8AR Rocking (Forward and Back) Sensation on Acceleration and/or Buzzing Noise

REVISION NOTICE

L-SB-0153-17 Rev1

Figure 2. New No. 1 Vacuum Transmitting Hose Routing

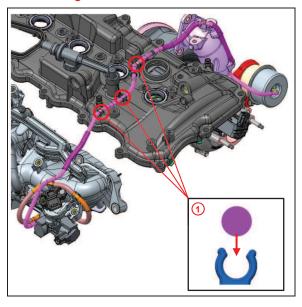
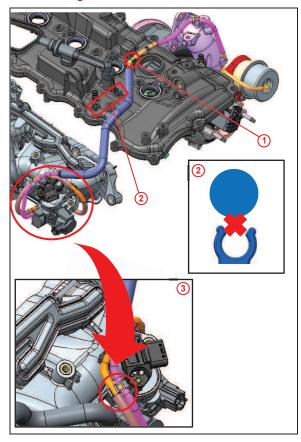
3. Replace the No. 1 vacuum transmitting hose with the NEW No. 1 vacuum transmitting hose. Follow the routing as shown in Figure 2.

Figure 1 shows the routing of the previous No. 1 vacuum transmitting hose.

No. 1 Vacuum Transmitting Hose Clamped to Cylinder Head Cover at Three Portions

No. 1 Vacuum Transmitting Hose Clamped to Cylinder Head Cover at One Portion

Cylinder Head Covers Incompatible With New No. 1 Vacuum Transmitting Hose

Additional Clamp Point (No. 1 Vacuum Transmitting Hose is Clamped to Other Hose

by Using Hose Clamp)
